Deferred Submittal Requirements and Application

Permit #: 18-209873-DFS-01-RS

Street Address:	7125 SW 45TH AVE	
Description of Work:	SINGLE PDF- DFS FOR TRUSSES	
The following assumptions were made when reviewing your project:		
Building Area	Stories	Sprinklers
3,054 SF	2

STRUCTURAL CHECKSHEET

SHOP DRAWING / SUBMITTAL REVIEW

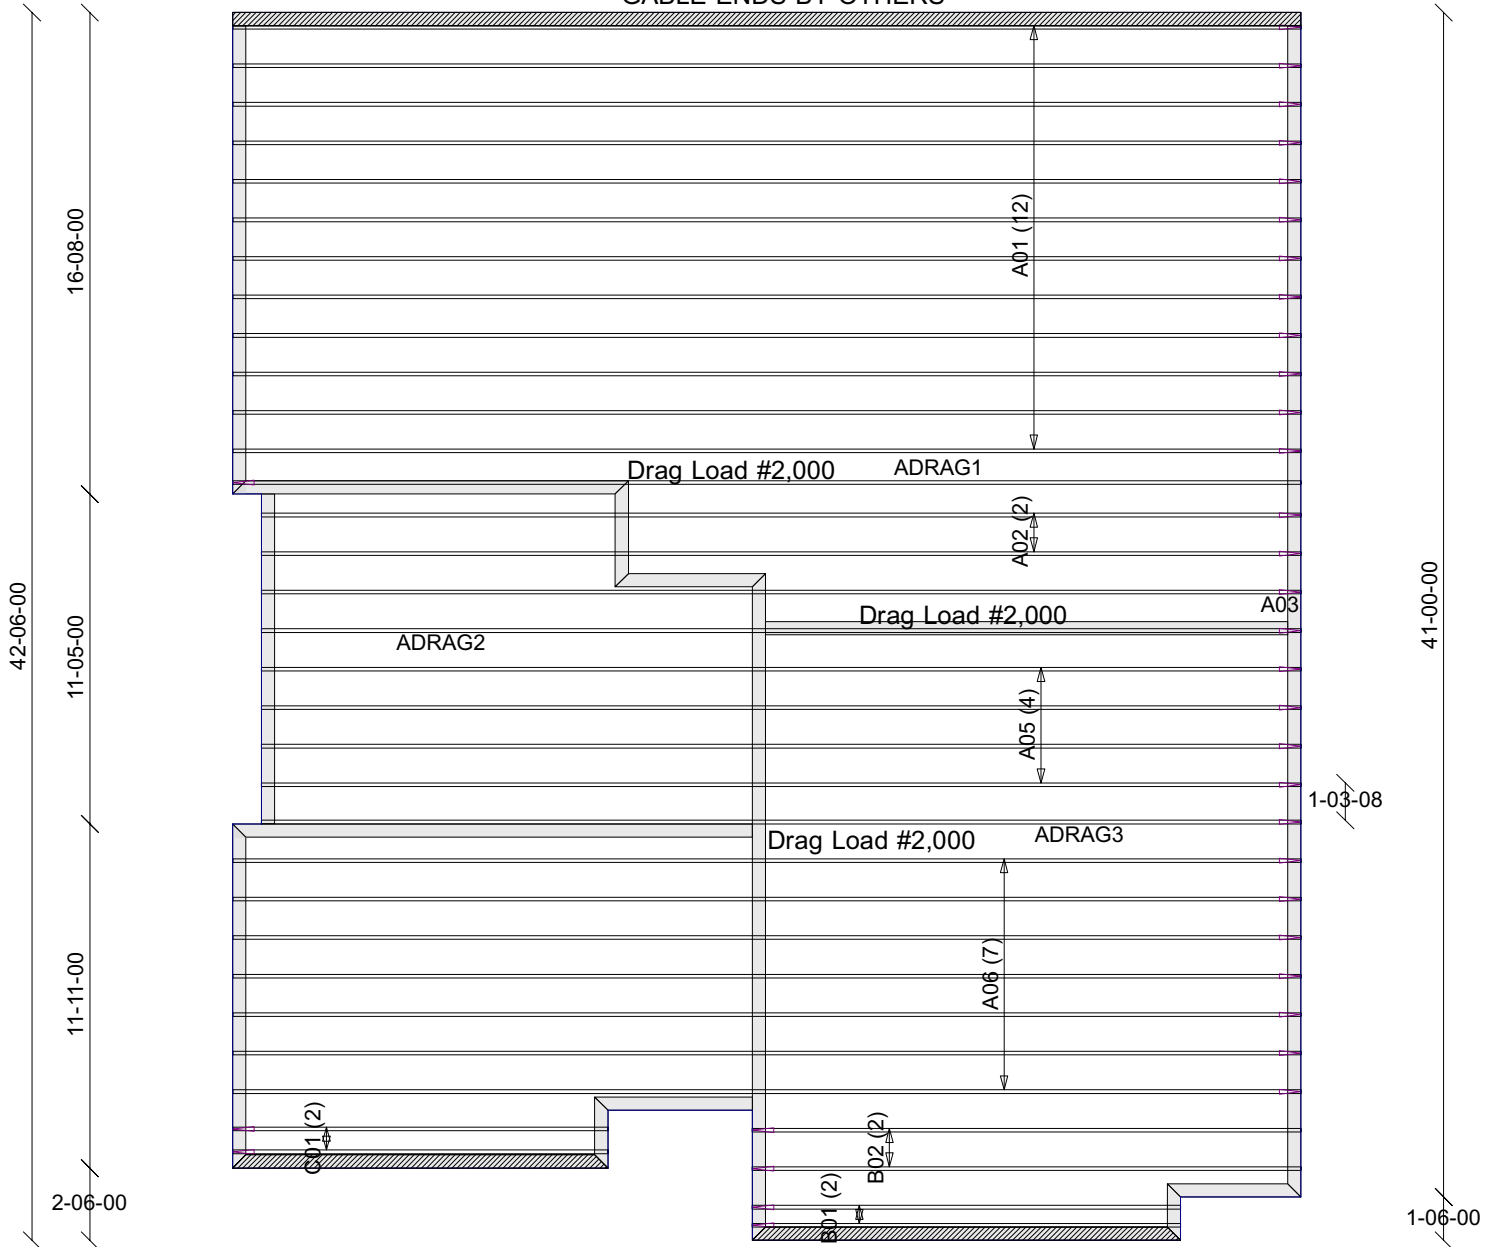
Based on the plans and specifications submitted, the following items appear to be missing or not in conformance with the Oregon Structural Specialty Code and / or other city, state, or federal requirements.			
Item #	Location on plans	Code Section	Clarification / Correction Required
1.	General	OSSC 107.2.1, ORSC R106.1.1	When responding to check sheet items, please cloud the revisions and/or additional information on the drawings submitted and itemize the changes on the Structural Checksheet Response page provided to expedite the review process.
2.	General	OSSC 1604.4, ORSC R301.1	The truss calculation layout plan does not match the truss layout indicated in the Roof Framing Plan on sheet S3. Please clarify/revise.
